**Objection points and Land and Mineral Management (LMM)  
and Officer responses**

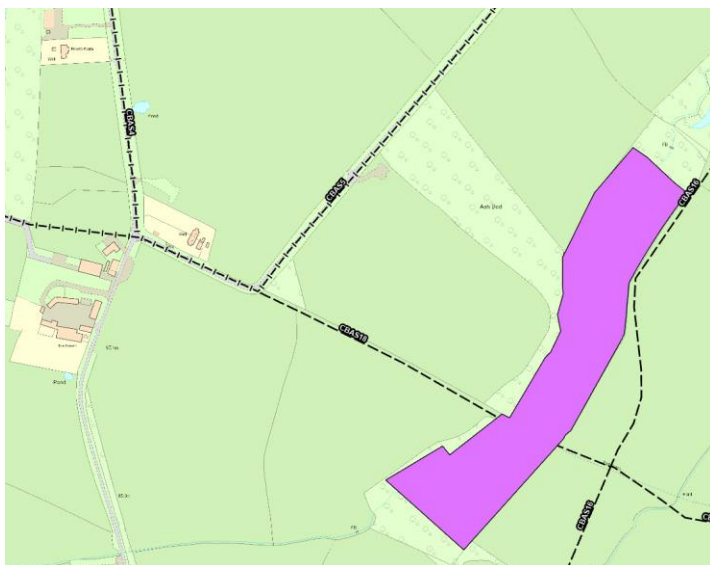
8. Objection – *The track that forms part of the bridleway is of historical value appearing on several old maps and should be retained.*

Officer response – The granted development lies directly over these routes therefore they must be temporarily diverted for health and safety of the public and operational control of the site. When the rights of way return to their original line, they will be required to be certified by Wiltshire Council so they must be in a suitable condition as stipulated by the Countryside Access Officer.
